NATIONAL WEATHER SERVICE

Engineering Handbook

MODIFICATION INDEX - AMOS III-70/73

AUTOMATIC OBSERVING EQUIPMENT MODIFICATION No.1
(For Electronics Technicians)

FIGURE 1

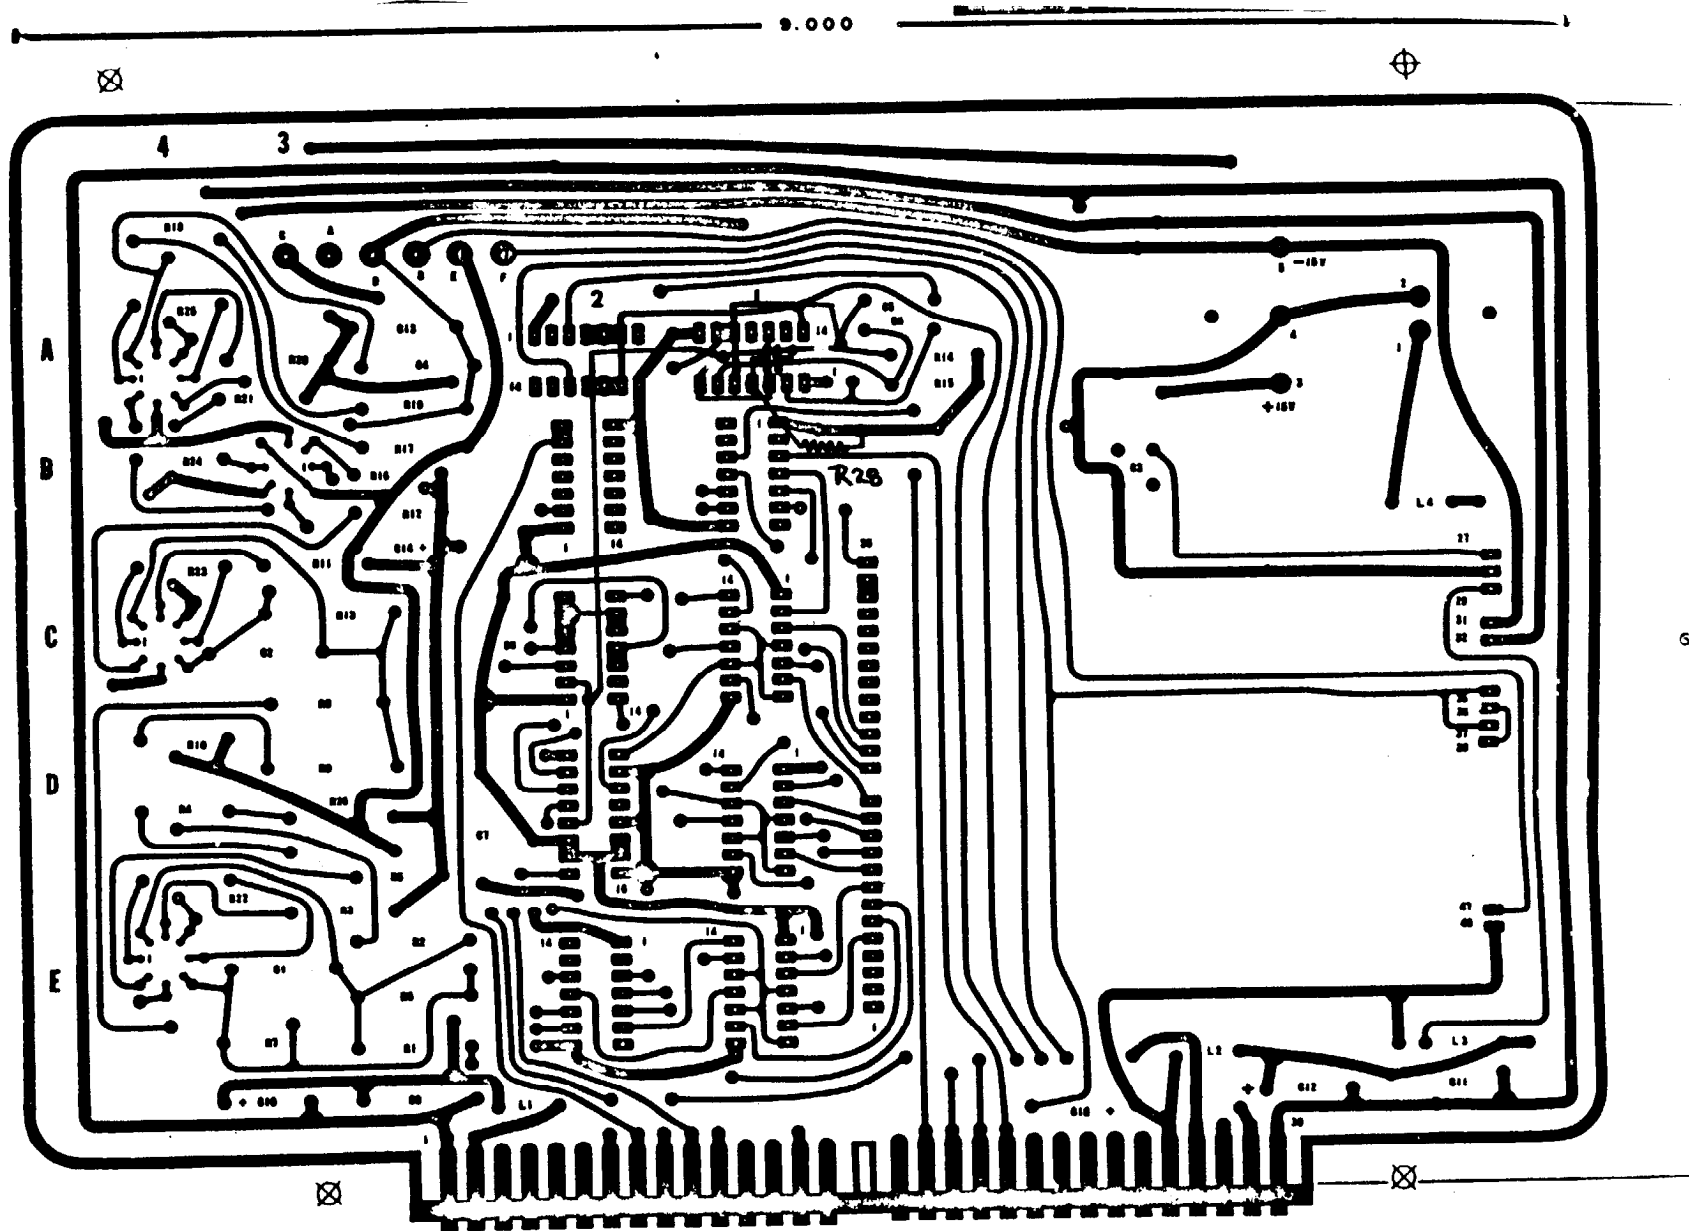
6. With an Exacto-type knife cut the "land run" which joins pin 7 of 1-PG-1 to C5 and R14. Make the two cuts as shown in Figure 1. Insure that there is enough land area to solder to on each end of the cut "land run."

8. Using the 1-1/2" jumper wire, solder one end to pin 5 of 1-PG-1 and the other end to the "land run" that connects C5 to R14, Refer to Figure 1. Be sure the jumper is insulated with sleeving and press it flat against the circuit board.

9. Solder the remaining 1/2" jumper wire between pins 3 and 7 of 1-PG-1. Make certain the jumper is insulated with sleeving and press it flat against the circuit board. Refer to Figure 1.

10. Solder the .001 mf. capacitor between the center portion of the "land run," cut in Step 6, and pin 4 of 1-PG-1. Refer to Figure 1, Keep the capacitor leads short with the capacitor close to the circuit board and free of short circuits.

11. Solder one end of the 5.1 K resistor to pin 4 of 1-PG-1 and the other end of the resistor to the "land run" that connects R15 to pin 1 of 1-GAT-17 (SP300A), chip 1 B, at coordinates B/1. Refer to Figure 1. Keep the resistor leads short with the resistor close to the circuit board and free of short circuits.

FIGURE 2

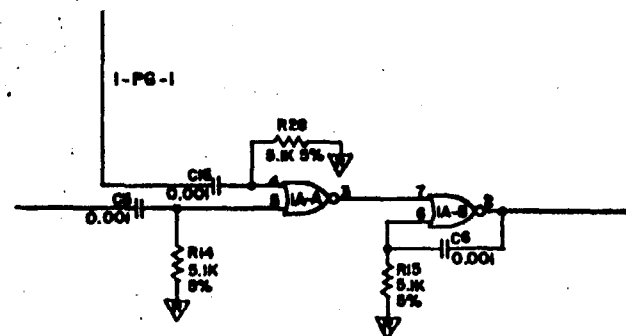
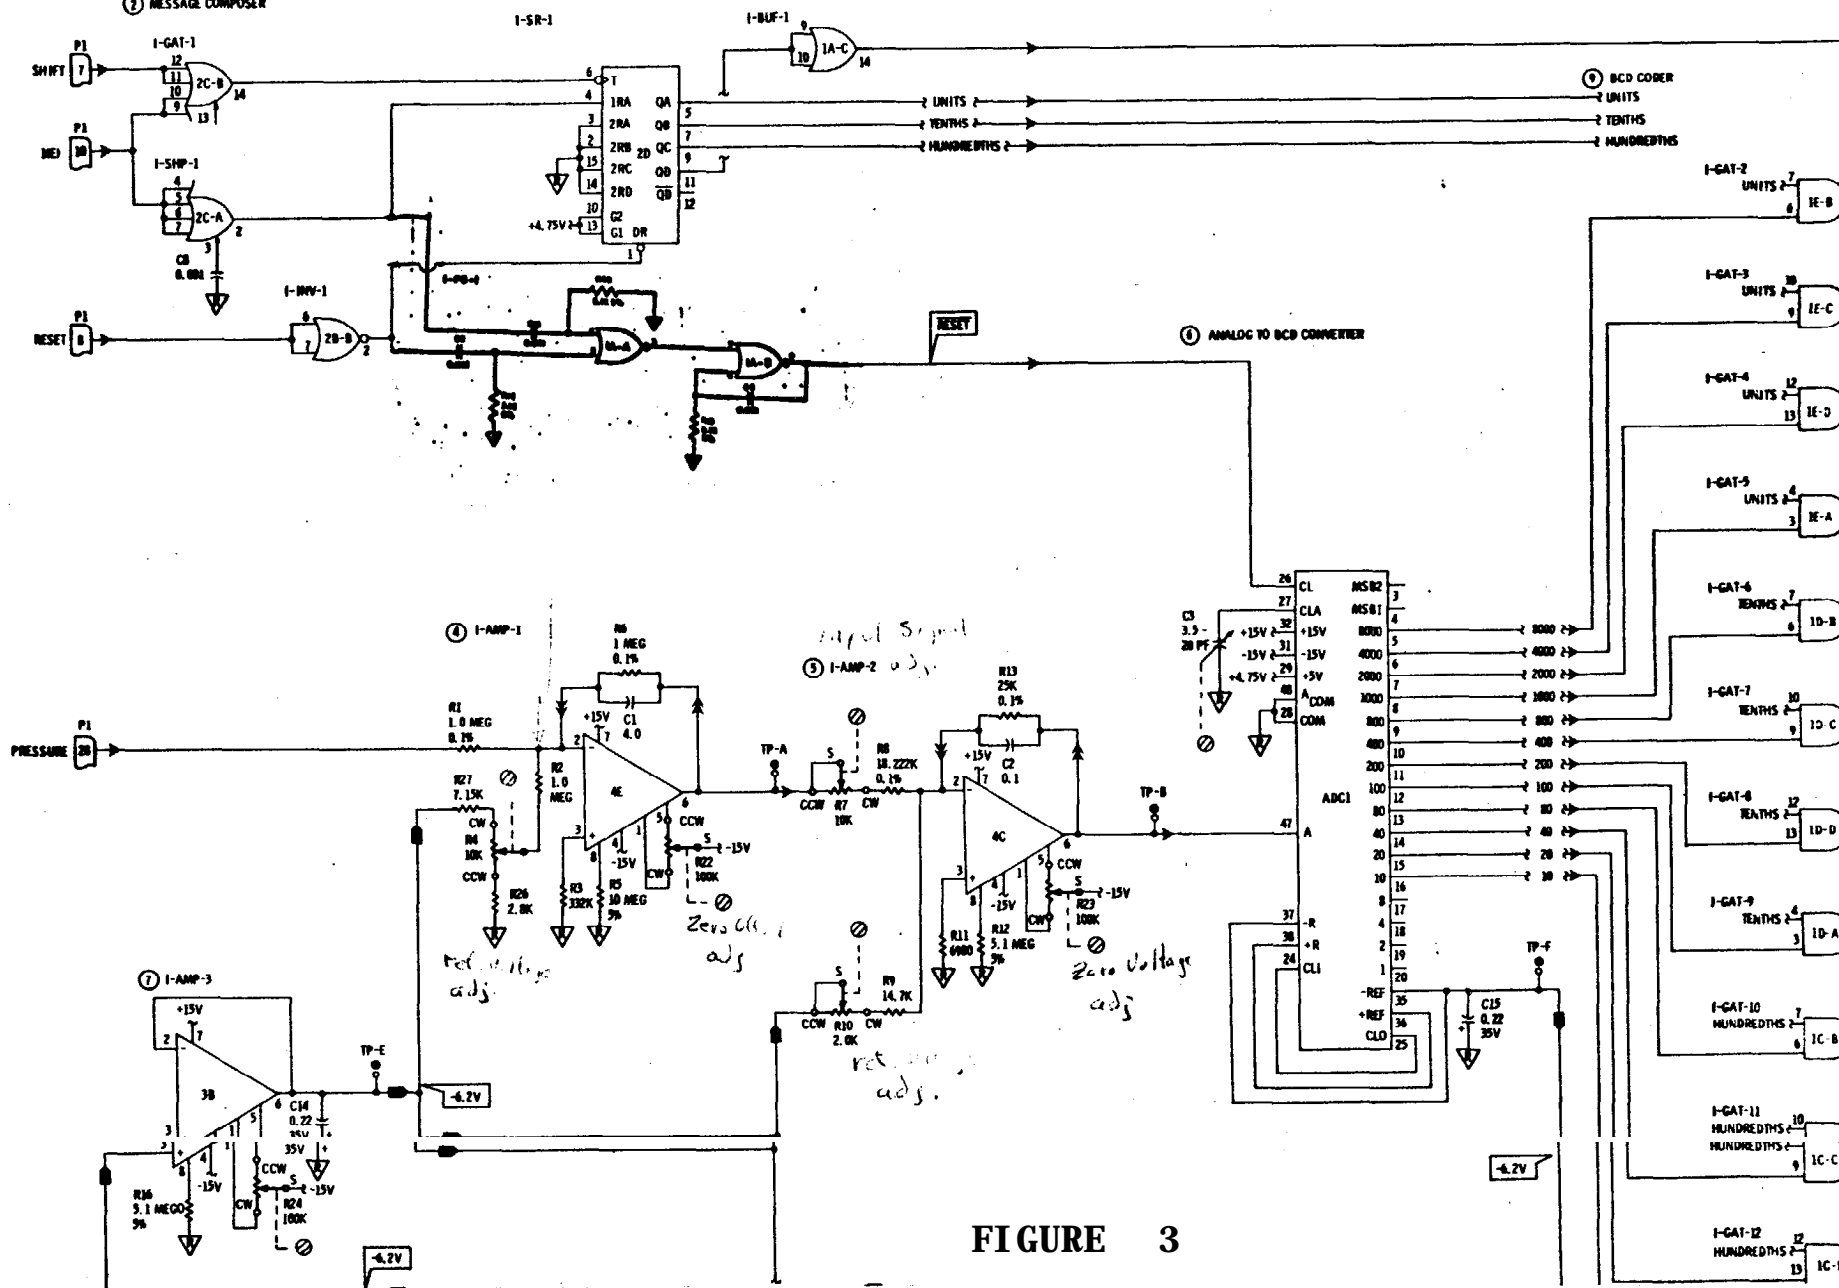
1. AMOS Manual No. 11-103 Volume 2:
- a, Page 2-171, make appropriate changes to the schematic by affixing Figure 2 of the attachments to the schematic as shown in Figure 3 of the attachments.
 - b. Page 2-176, insert in the Parts List, the additional capacitor (C16) and the resistor (R-28) of this modification into their proper places.

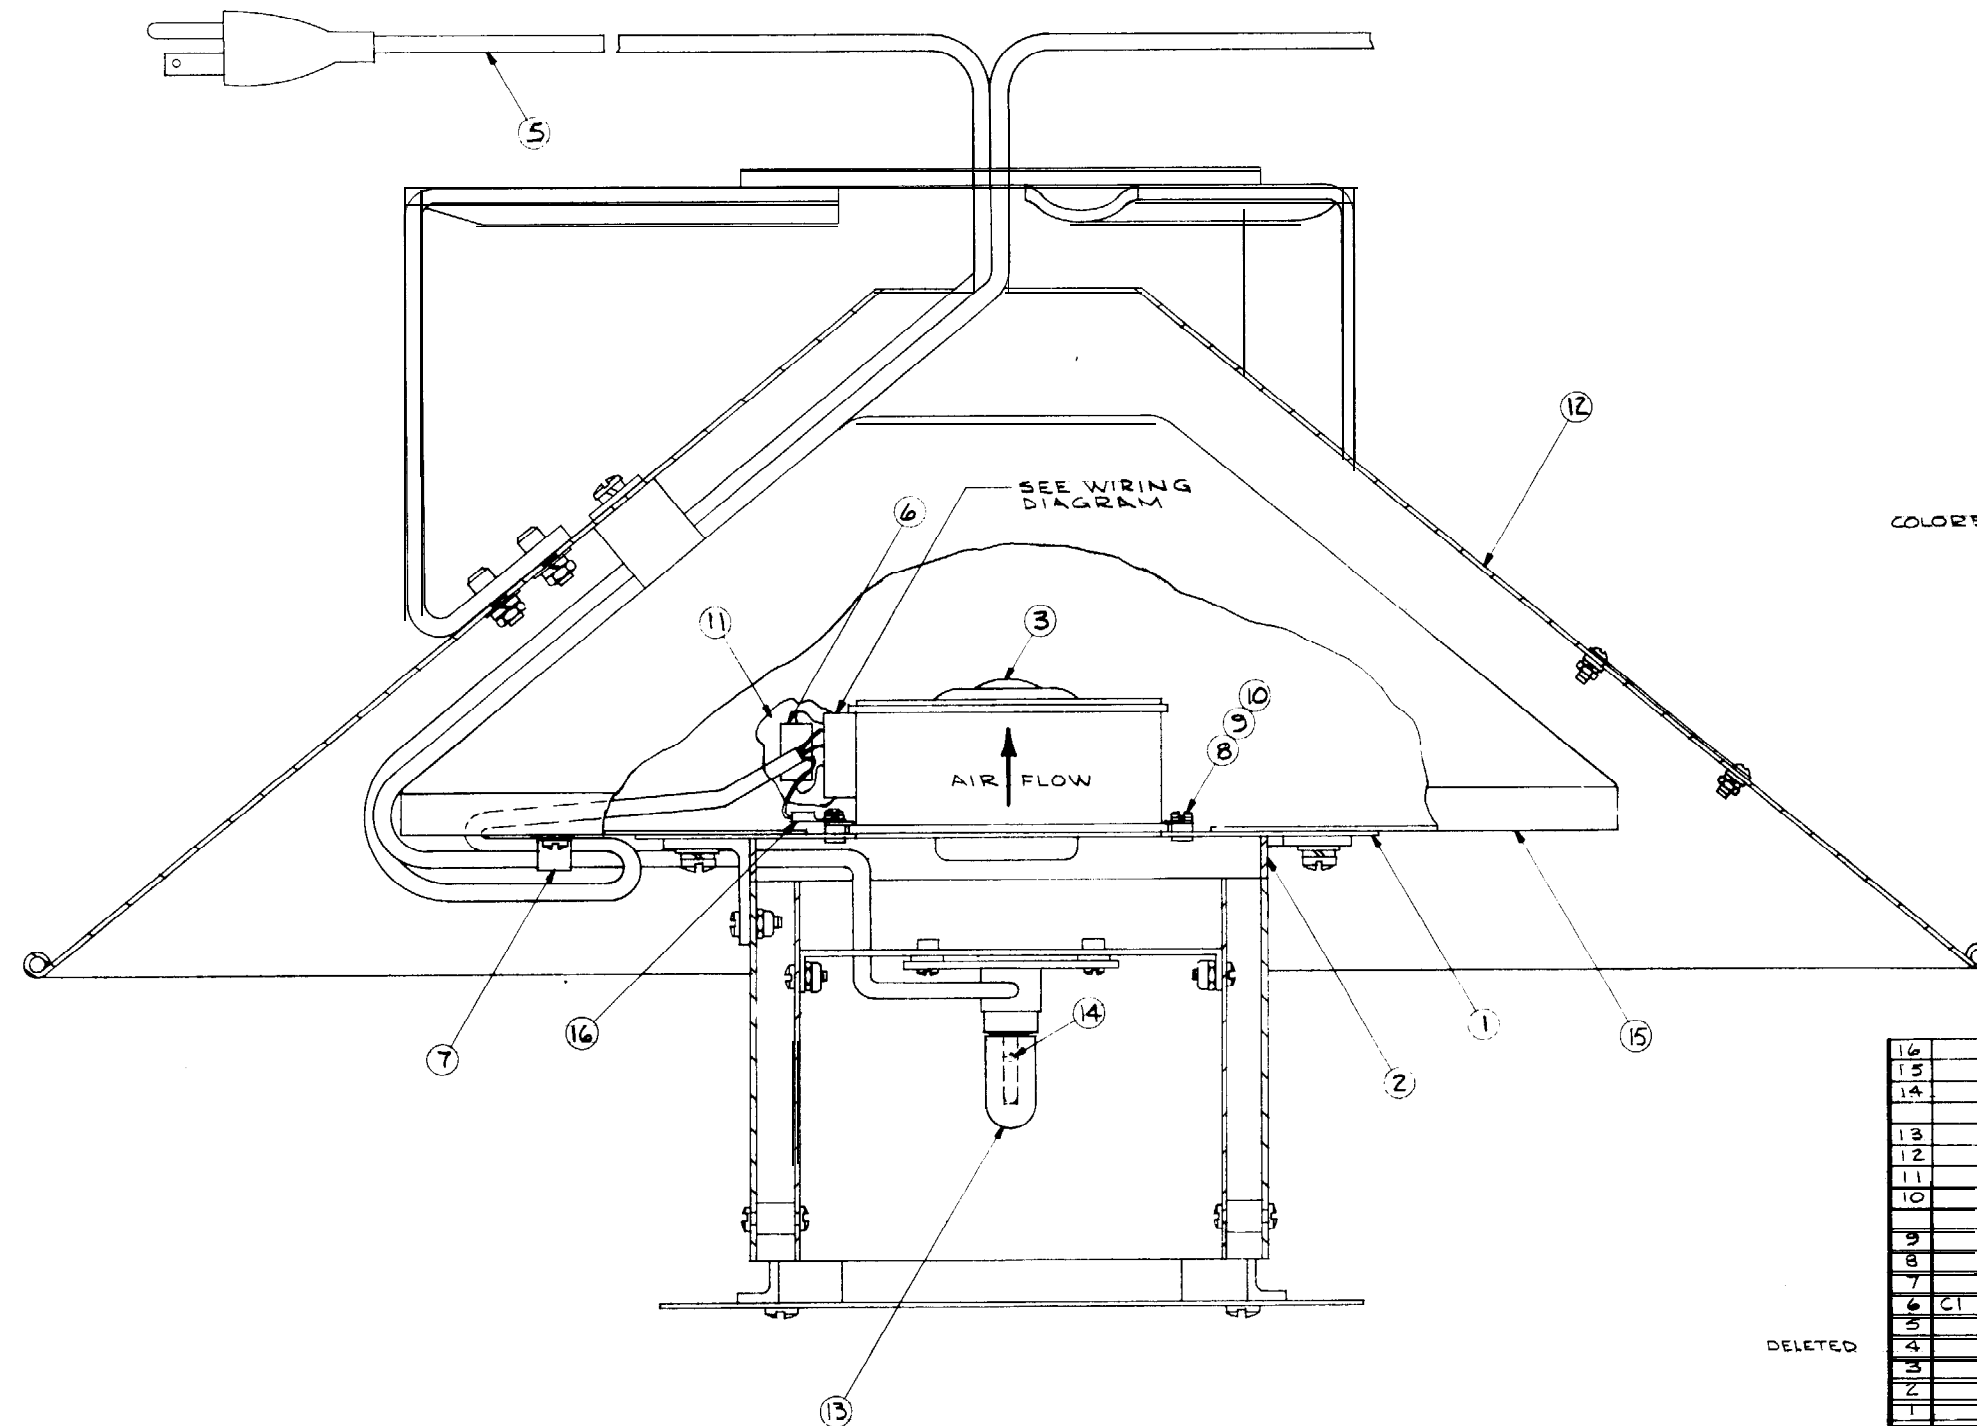
11. With a knife or other appropriate tool scrape the painted holes of the sensor plate, supplied with kit, to assure a good ground. Install the Rotron fan furnished in the mod kit on the sensor plate as shown in Drawing S010-F3T4. Secure the fan with the cleats, screws and washers as shown. (Note that airflow direction arrow conforms to Drawing S010-F3T4. Arrow direction is on fan.)

13. Connect the ring lug provided in the mod kit to the green wire on the power cable. Carefully remove lugs provided with Rotron fan. Spaghetti both ends of C1, (.5 uf capacitor). Join one end of capacitor and white lead of power cable to one of these lugs. Crimp and solder. Connect the other end of capacitor to a fan lug. Crimp and solder. Connect the capacitor and power cable to the fan terminals as shown in Drawing S010-F3T4 wiring diagram.

19. Install set screw into Thermal Mass and then install thermal mass. (See Drawing S010-F3T4), over the transducer and secure with long metric hex wrench. Replace the plate cover partially removed in Step 18.

FIGURE 1

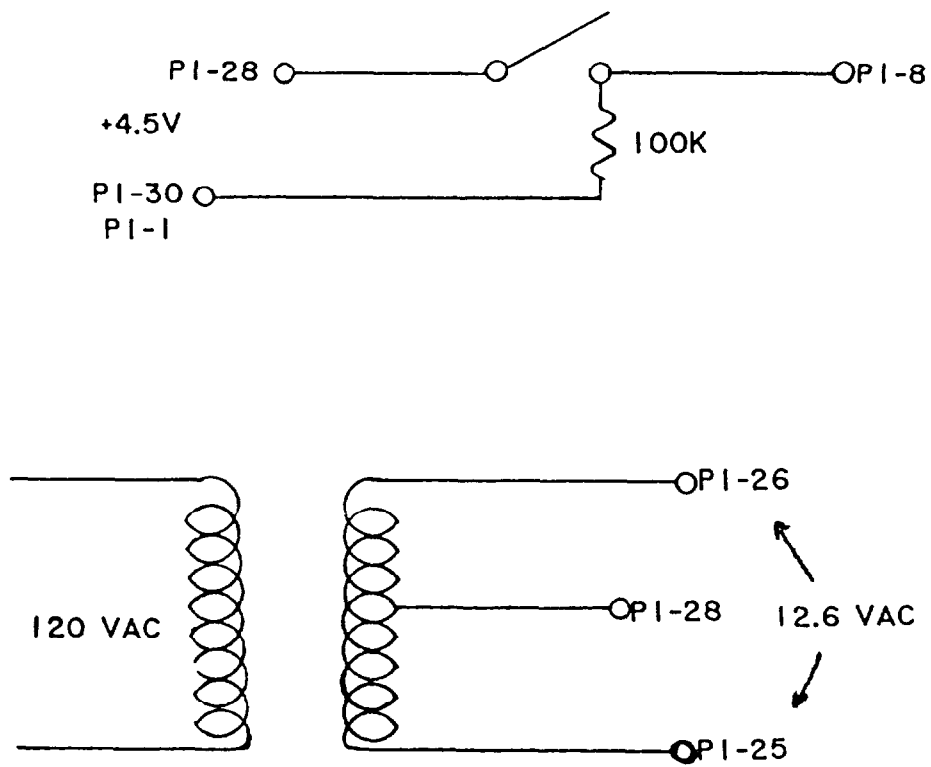
P1-28	+4.5 Vdc
P1-30	Return
P1-1	Return
P1-8	Reset (see Figure 1)
P1-26	12.6 Vac Hi (see Figure 1)
P1-25	12.6 Vac Lo (see Figure 1)
